Access Compliance Report

Public Rights-of-Way

(Curb Ramps)

Intersection ID: 8722	Main Street: LANDER_ST	Cross Street: ROZZELLES_FERRY_RD	Location: S
ADA ID: AD9AFA366A5E	Ramp Type: BlendTrans1	Initial Pass/Fail: Fail	Overall Compliance: No
Codes/Mitigation Info/Possible Solution		Field Measurements/Component Compliance	
Severity Score: 8.75

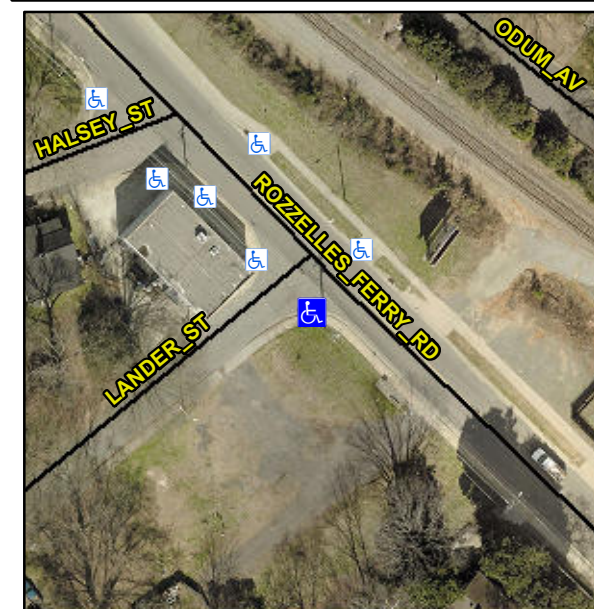
Not Found, R304.5.1

Compliance	Description	Data	Compliance	Description	Data
N/A	Ramp Length (in)	50.0	Yes	BlendTrans Slope (%)	4.6
No	Ramp Width (in)	44.0	Yes	BlendTrans XSlope (%)	1.8
N/A	Flare Type LT	N/A	N/A	Flare Type RT	N/A
N/A	Flare Slope LT (%)	N/A	N/A	Flare Slope RT (%)	N/A
N/A	Flare Traversable LT?	N/A	N/A	Flare Traversable RT?	N/A
N/A	Landing Length (in)	N/A	N/A	DWS Provided?	N/A
N/A	Landing Width (in)	N/A	N/A	DWS Contrast?	N/A
N/A	Landing Slope (%)	N/A	N/A	DWS Length (in)	N/A
N/A	Landing X Slope (%)	N/A	N/A	DWS Full Width?	N/A
N/A	Landing Curb? (Y/N)	N/A	N/A	DWS Offset (in)	N/A
N/A	Shared Landing?	N/A			
N/A	Gutter Ponding?	N/A	N/A	Gutter Slope (%)	N/A
N/A	Gutter Lip Ht (in)	1.0	N/A	Gutter X Slope (%)	N/A
N/A	Painted X Walk1?	No	N/A	Painted X Walk2?	No
	X Walk 1 Direction	To NE		X Walk 2 Direction	To NW
	X Walk 1 Width (in)	N/A		X Walk 2 Width (in)	N/A
	X Walk 1 Slope (%)	6.5		X Walk 2 Slope (%)	2.9
	X Walk 1 X Slope (%)	1.9		X Walk 2 X Slope (%)	2.8

N/A	Ramp inside XWalk1?	N/A	N/A	Ramp inside XWalk2?	N/A
	Road Slope (%)	2.1		Clear Space?	N/A
	Road X Slope (%)	4.4	N/A	Clear Space to XWalk (in)	N/A
N/A	Any Obstructions?	N/A	N/A	Storm Grate/Utility Hazard?	N/A
	Obstruction Type			Storm Grate/Utility Type	
		N/A			N/A
			Yes	Surface Condition? (G/P)	Good
			No	Curb Slope (%)	15.5

Remove & Replace Curb Ramp With Two New Directional Ramps or Equivalent.
